Service Bulletin

Bulletin No.: PIT4474D

Subject: Navigation or Radio Display Blank Or Flashing DTC B1265 B1288 Or B1289

Models: 2007-2013 Cadillac Escalade Models
2007-2013 Chevrolet Avalanche, Silverado, Suburban, Tahoe
2007-2013 GMC Sierra, Yukon, Yukon XL, Yukon Denali, Yukon Denali XL

2901600

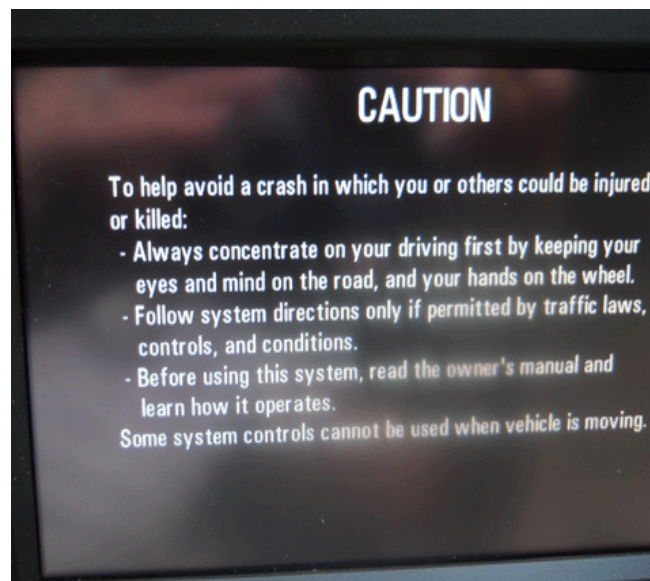
- Navigation or radio screen is blank or flashes on and off
- No sound from speakers
- Rear DVD screen inoperative
- DTC B1265, B1288 Or B1289
- Navigation disclaimer message intermittently will be displayed (see below)
